SUBJECT: STANDBY LIQUID CONTROL SYSTEM SODIUM PENTABORATE CONCENTRATION  
(TAC NO. 61255)

Re: HOPE CREEK GENERATING STATION

AMENDMENT TO FACILITY OPERATING LICENSE

Amendment No. 11  
License No. NPF-57

FIGURE 3.1.5-1

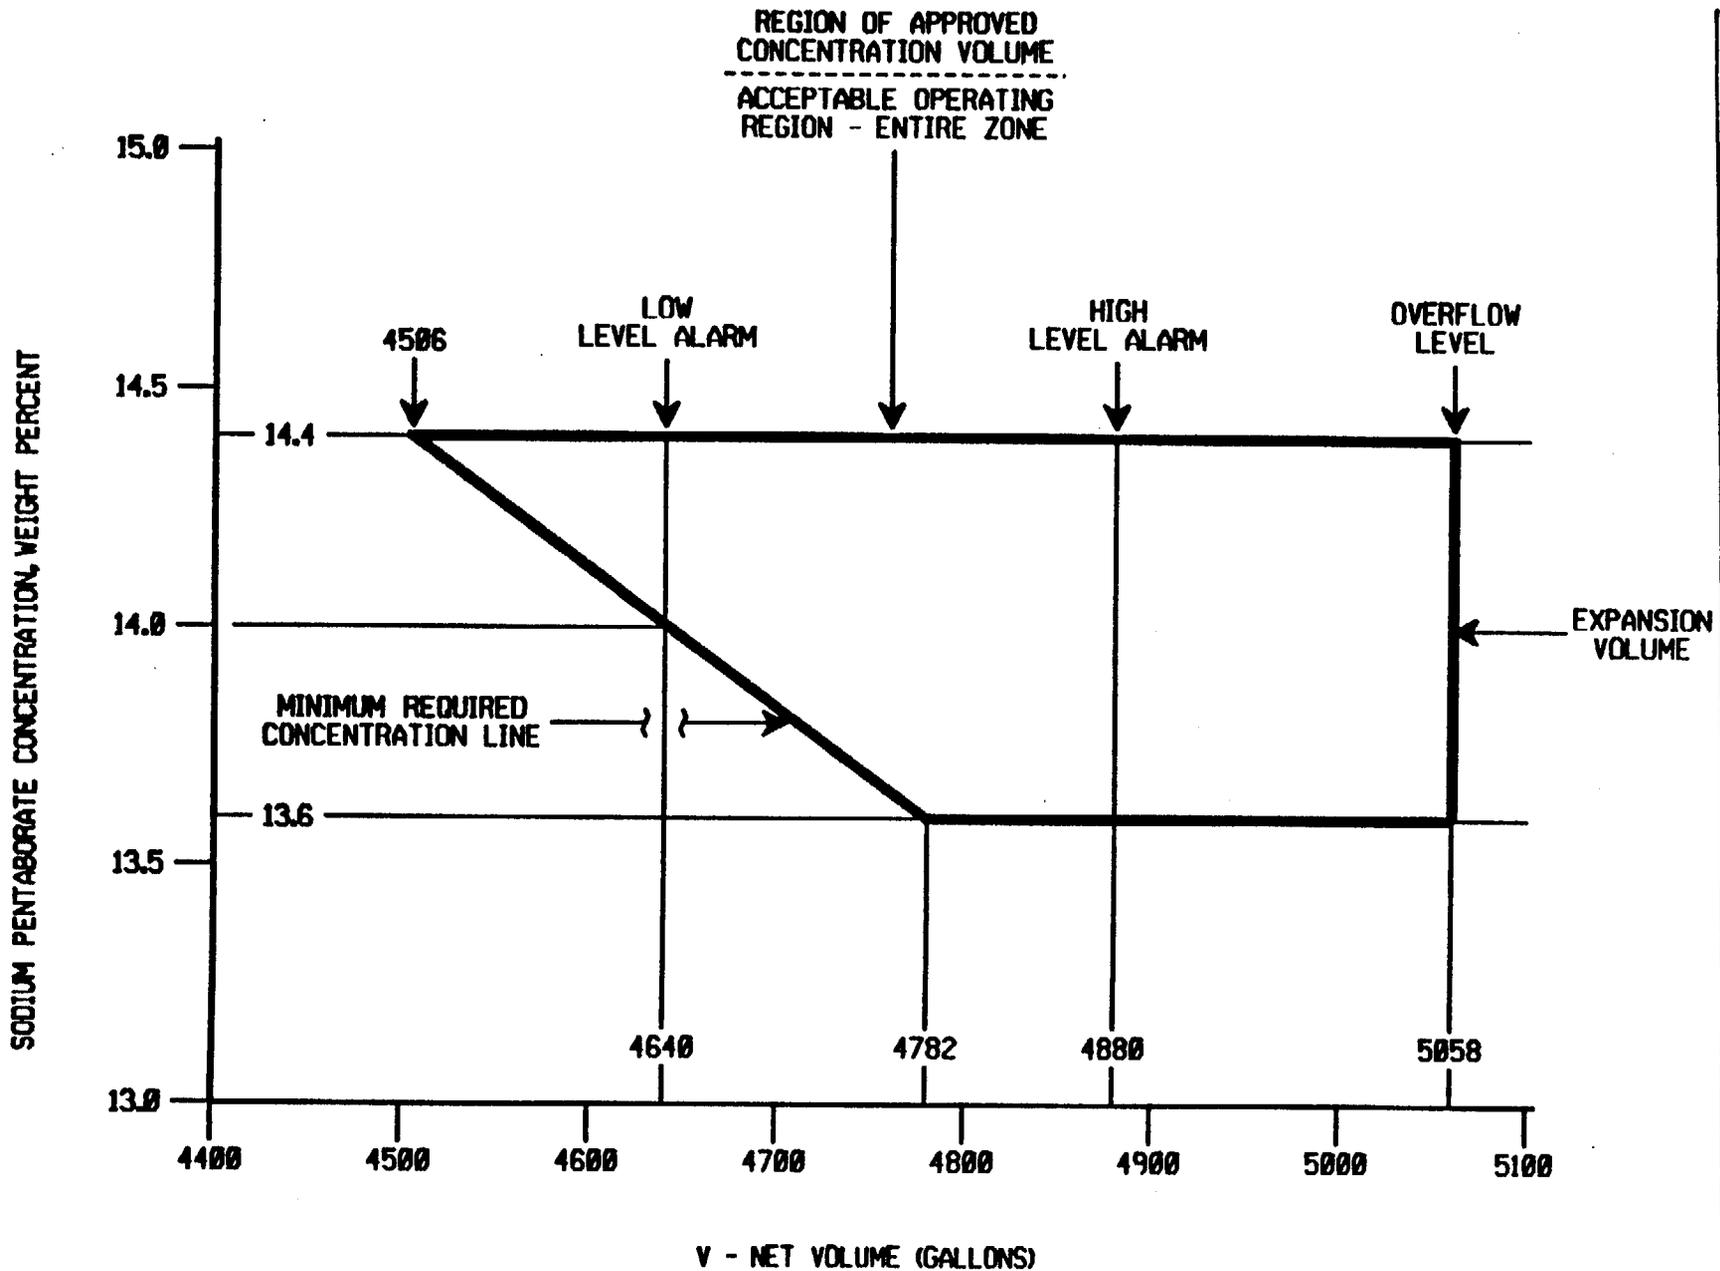
This amendment increases the minimum required concentration and the minimum required weight of sodium pentaborate in the standby liquid control system storage tank.

- b. At least once per 31 days by:
1. Verifying the continuity of the explosive charge.
  2. Determining that the available weight of sodium pentaborate is greater than or equal to 5,776 lbs and the concentration of boron in solution is within the limits of Figure 3.1.5-1 by chemical analysis.\*

The changes proposed by the licensee have been reviewed by the staff against the requirements of the ATWS Rule (10 CFR 50.62), and Generic Letter 85-03 "Clarification of Equivalent Control Capacity for Standby Liquid Control Systems," dated January 28, 1985. The licensee's proposed increase in sodium pentaborate concentration to 13.6 weight percent in conjunction with a flow rate of 82.4 gpm will provide a boron

content equivalent in control capacity to 86 gpm of 13 weight percent sodium pentaborate. This is in compliance with 10 CFR 50.62(c)(4) and is therefore acceptable.
